February 17, 2017

Project IR15165930

**Re: Comments on the 2016 Final Remedial Investigation Report
Former Marchant/Whitney (FMW) Site
5679 Horton Street, Emeryville, California**

Figure 3
1949 Sanborn Map
FMW Site and Surrounding Area
5679 Horton Street, Emeryville, California

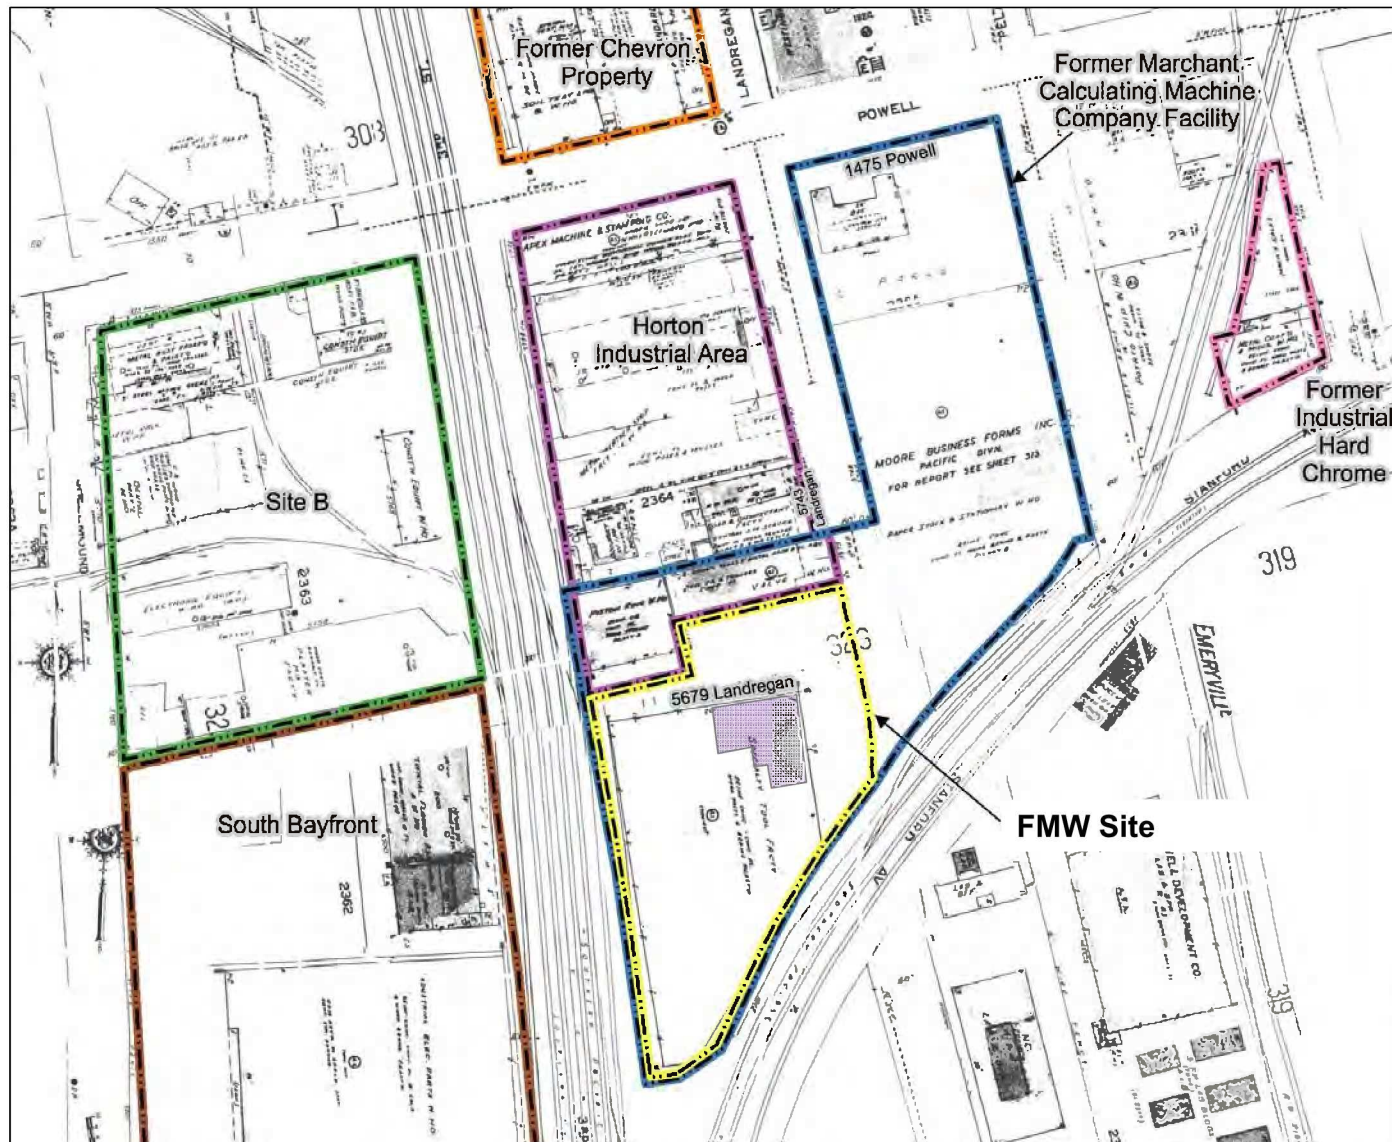
The areas and operations associated with the Marchant Facility identified by EKI in the 2016 Report (pages 2-2 and 2-3) included a nickel plating area, an enameling area, a grinding room, a press room, an assembling room, a machine shop, an experimental machine shop, a tool shop, a dressing room, shipping, a store room, storage and service department, a 20,000 gallon water tank filled by an onsite groundwater well, a machine inspection room, a press room, a tool room, bench works, a hardening and plating room, office, and spring department. In the Executive Summary of the 2016 Report (page ES-1), EKI noted a number of areas and operations associated with the Marchant Facility as listed above. EKI did not include in the Executive Summary any reference to the hardening and plating room, although it did refer to it in the body of the 2016 Report. The hardening and plating room is identified on the 1947 Sanborn map (Figure 3), which was identified by EKI as the primary source area in 2012 Report (EKI, 2012, page ES-2 and pages 6-3 and 6-4 in Section 6.2.2, and Figure 6-2a). The hardening and plating room occupied a rectangular area of approximately 27 feet wide (east-west axis) by approximately 110 feet long (north-south axis), and the footprint of the room underlies northeastern corner of the Current Building, and the area just east and north of the Current Building. The approximate location and boundaries of the Marchant hardening and plating room are noted on Figure 3.

Figure 4
1967 Sanborn Map
FMW Site and Surrounding Area
5679 Horton Street, Emeryville, California

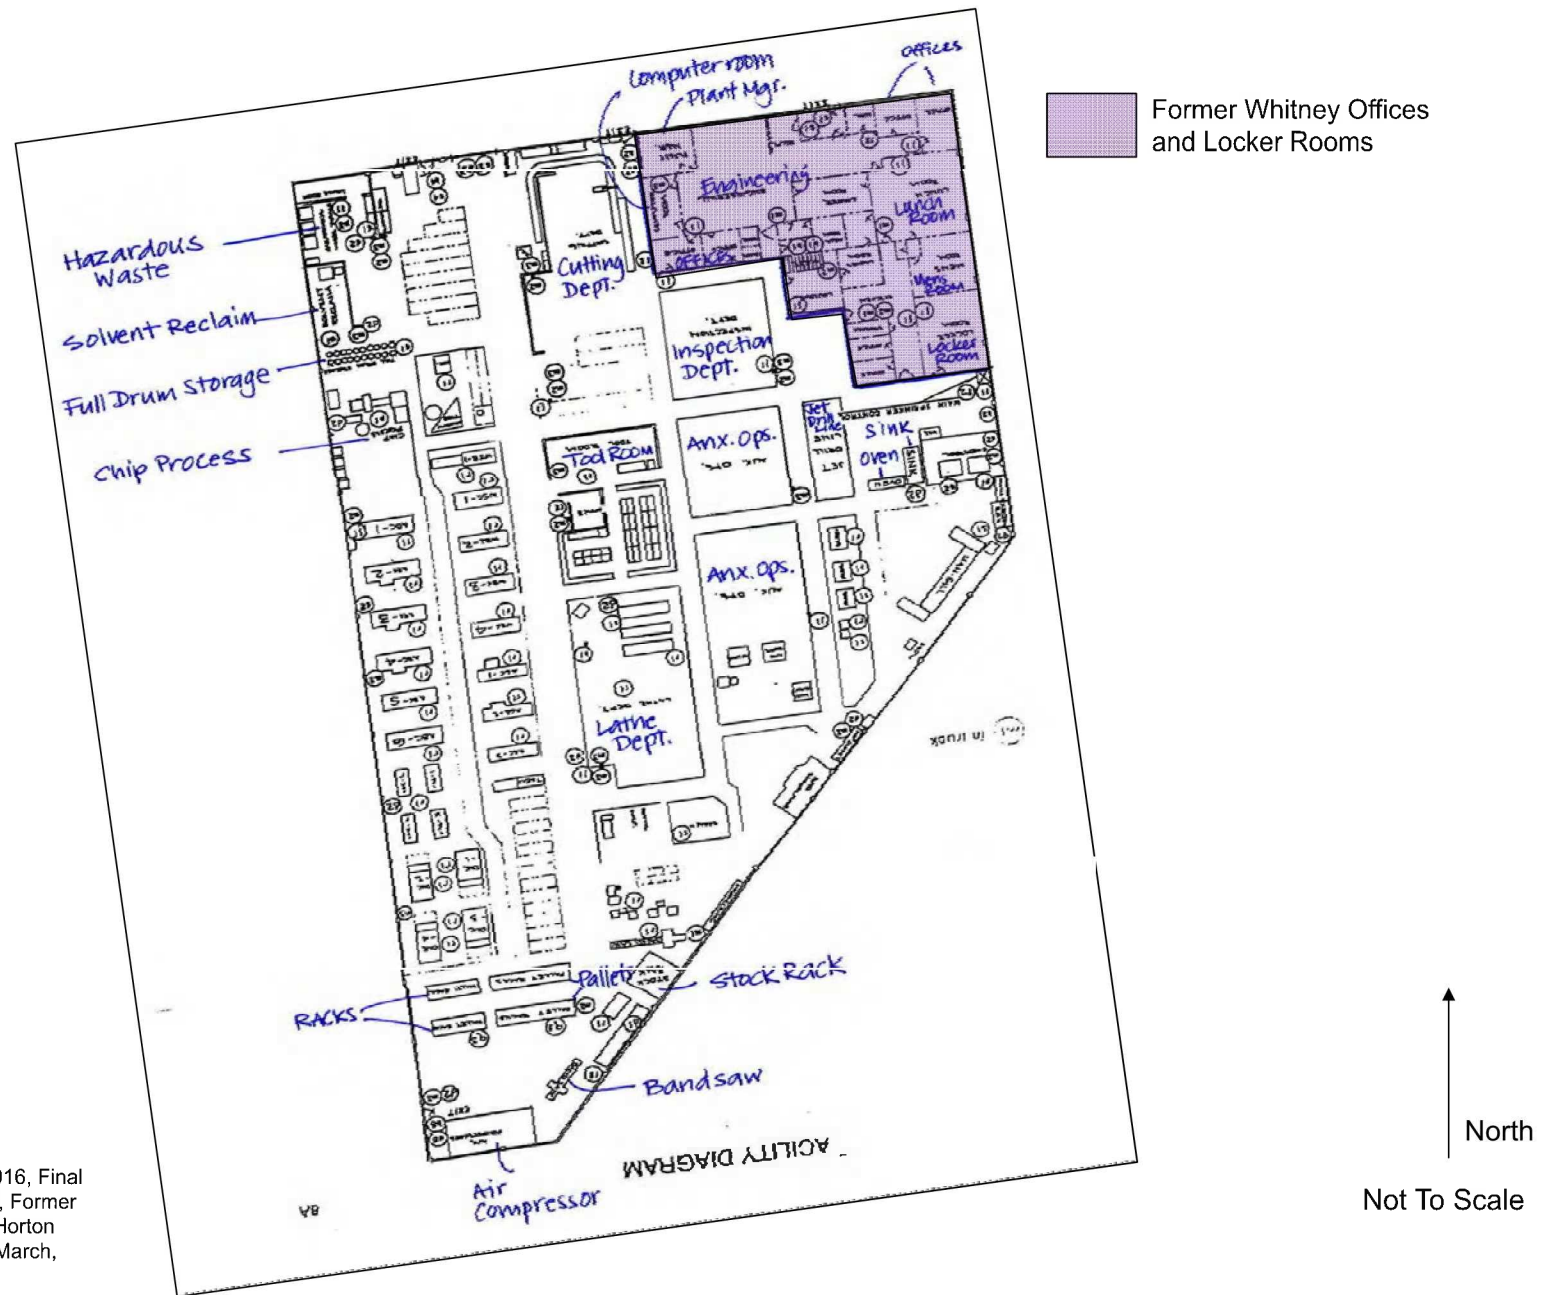
In the late 1950s or early 1960s, the Marchant Facility was demolished, but the Marchant Facility's concrete floor slab on the FMW site (old slab) was left in place, as documented in the 2016 Report (page 2-4, Section 2.2.2) and as shown on a 1963 as-built titled "Plot Plan" included in Attachment 2 of this letter (Appendix A, 2016 Report). The Current Building is shown on the 1963 as-built titled "Plot Plan" and Figure 4 (1967 Sanborn map; EKI, 2016a, Figure 2-1h).

Figure 7
Layout of the FMW Site
5679 Horton Street, Emeryville, California

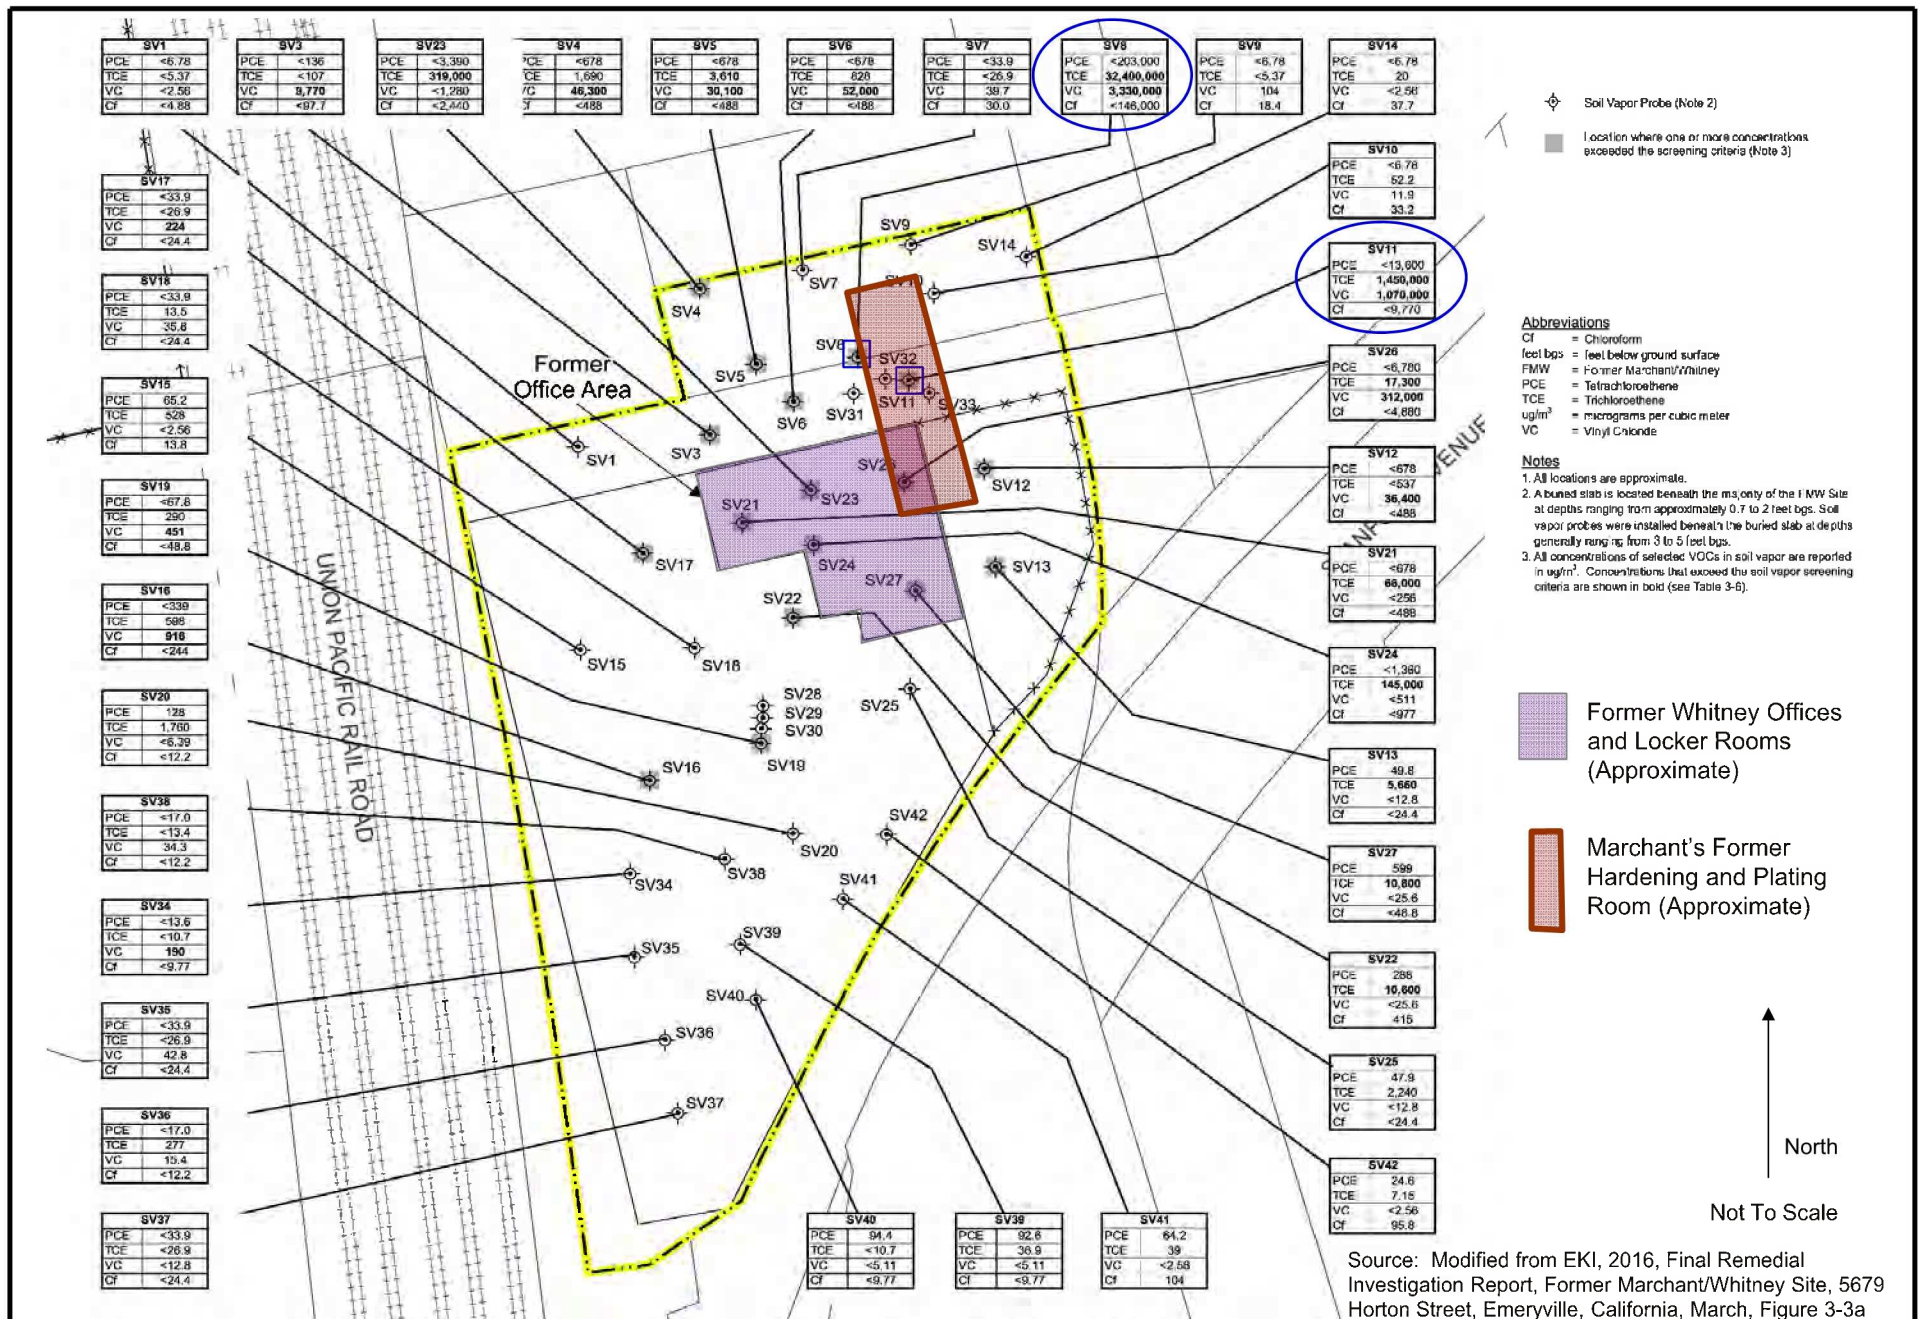
In Section 4.4 of the 2016 Report, EKI targeted three on-site areas as the source of the TCE (and other VOCs) at the FMW site. The three on-site areas shown on the inset map to the right (modified from EKI, 2015a) and on Figure 7 are:

Figure 8
Soil Vapor Sample Results (Below Old Slab)
5679 Horton Street, Emeryville, California

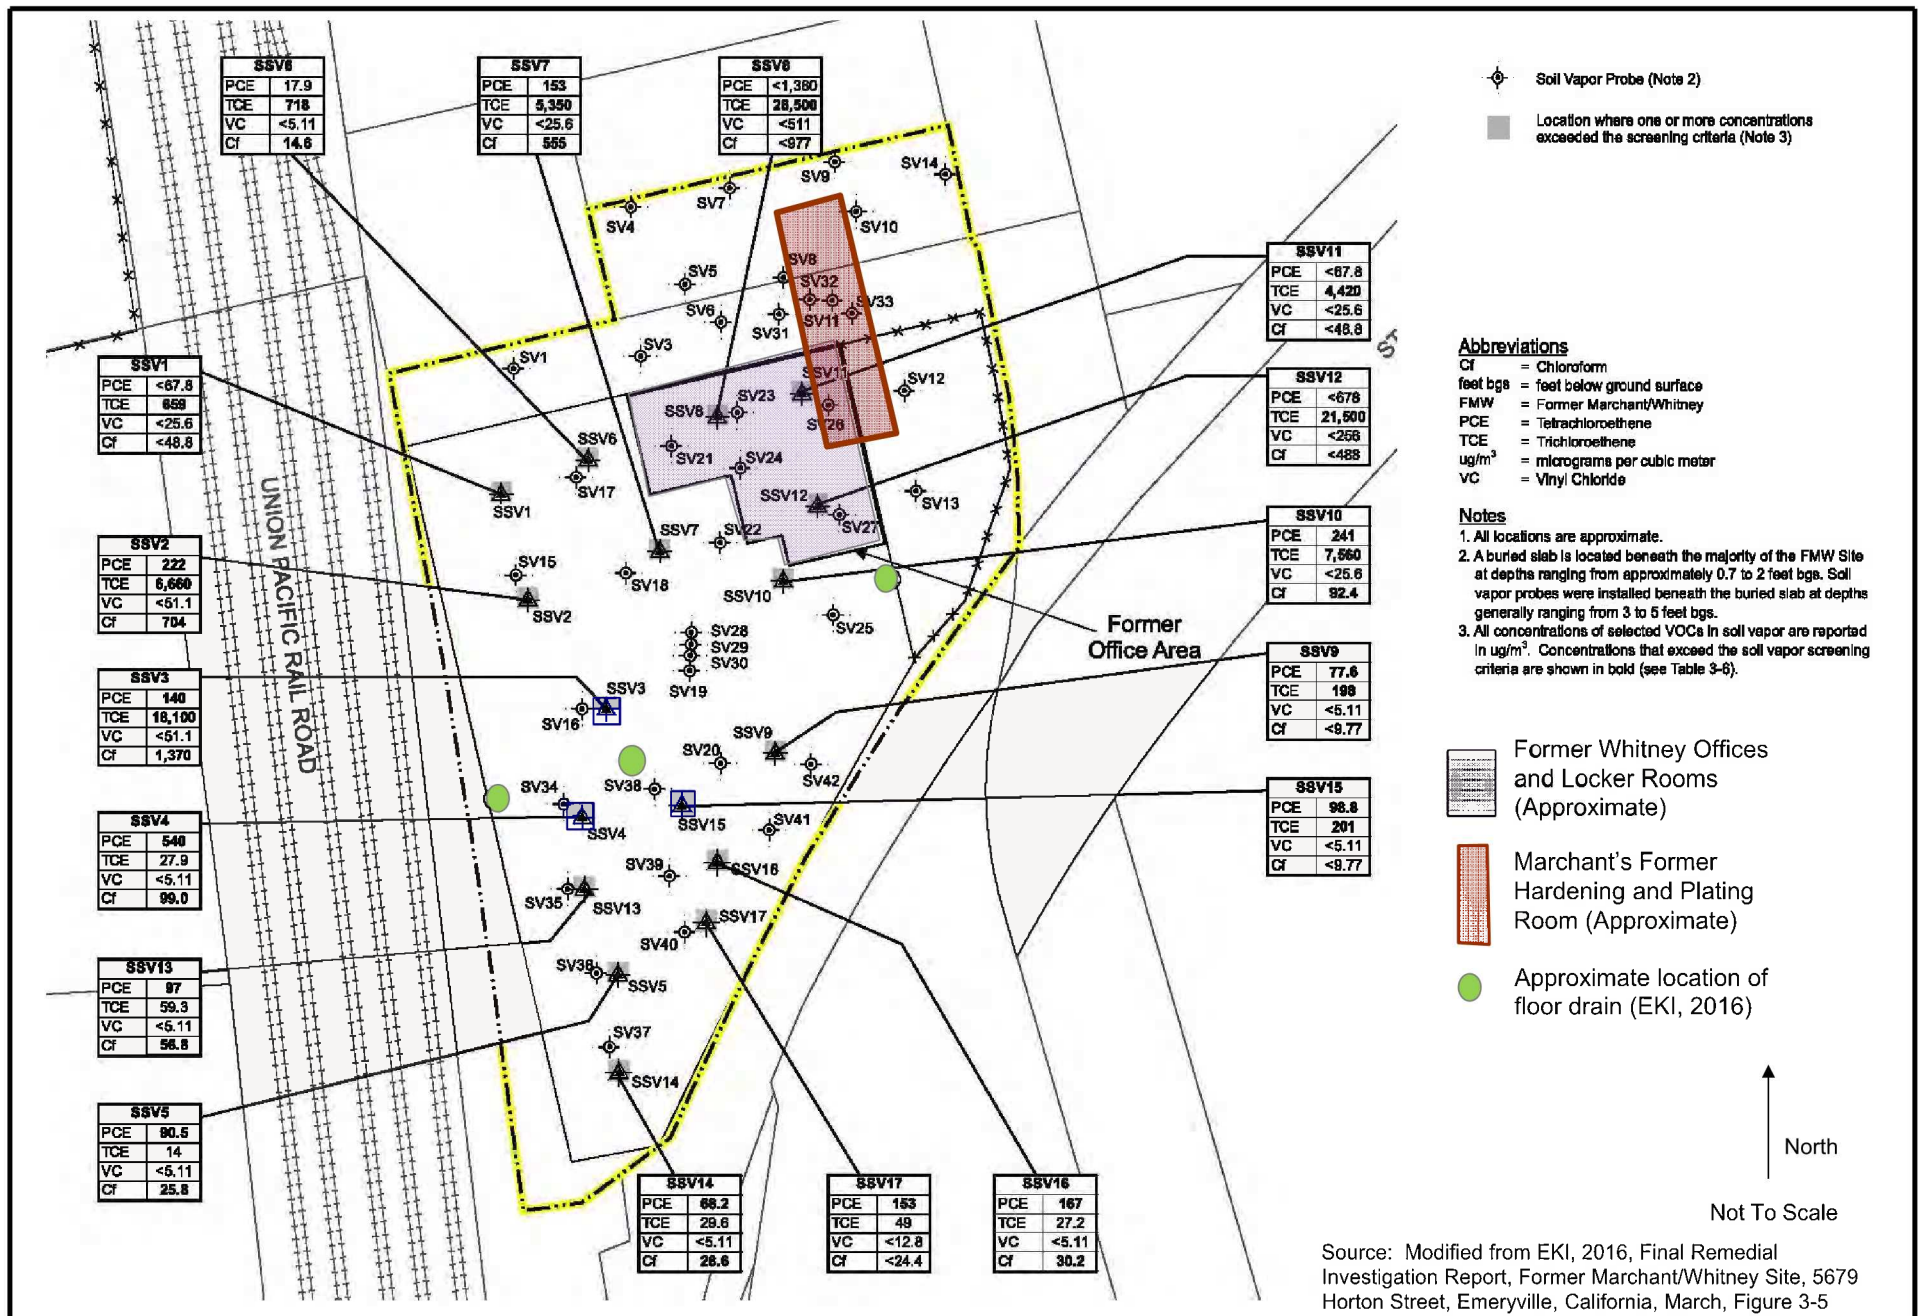
The highest TCE vapor concentrations were observed at SV8 and SV11 (Figure 8), outside the northeast corner of the Current Building and where Whitney’s parking lot was located. The area in which SV8 and SV11 are located overlies the northern portion of Marchant’s hardening and plating operations (EKI, 2016a, Figure 2-2f – 1983 Aerial Photograph; Figures 2-1d, 2-1e, and 2-1f – 1949, 1961, and 1952 Sanborn Maps). Marchant likely used and/or stored TCE in this area based on the operations related to the hardening and plating room and Marchant’s use of TCE at its Berkeley Location; by contrast, there is no evidence that Whitney handled TCE in a paved parking area for the facility adjacent to the main entrance to the office area (EKI, 2016a, Figures 2-2d, 2-2e, and 2-2f – 1965, 1971, and 1983 Aerial Photographs, respectively).
